# SEMMES AVE AT COWARDIN AVE

FEBRUARY 2026

\*This is a draft sketch that is being used in an upcoming DOT Smart Scale grant application. The designs are conceptual, are not final, and may change pending additional community engagement. If successful, grant funding would be available in 2032.

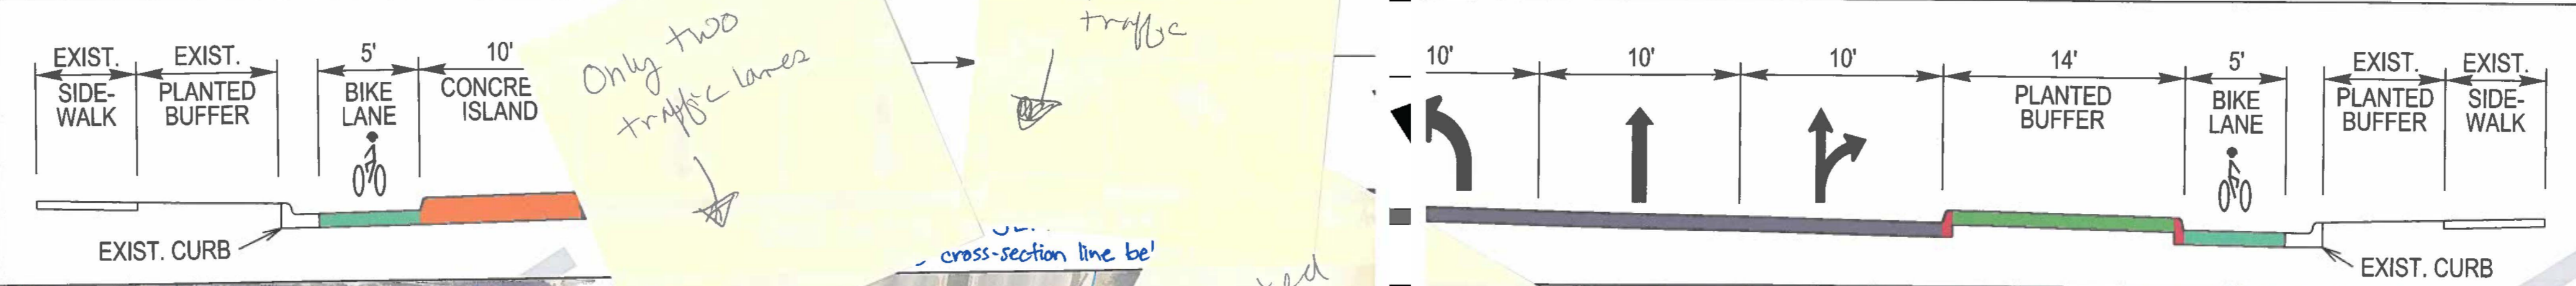
Overhead utilities should be placed underground - one fatal accident at Semmes + W 20th w/ vehicle hitting pole

SIGNAGE / ART HERE

Reduce number of lanes from 4 to 3

Like a median speed camera camera this intersection + lane Bldg

BIKE PATH CONNECTION HERE

When was the last intersection signal study done?

Get rid of turning left lane. Traffic doesn't warrant it and it encourages speeding

Architectural standards for multi-family

lacked of context "island," why not

Reduce # of lanes to 3

Reduce # of lanes to 3

Pedestrian signals MUST WORK all of the time

Pedestrians should given priority vehicles should yield when pedestrians

25 MPH

slow traffic increase green infrastructure with bump outs

BIKE PATH CONNECTION TO CSX EASEMENTS

MORE crosswalks

ELEVATED CROSSWALKS / SPEED TABLES
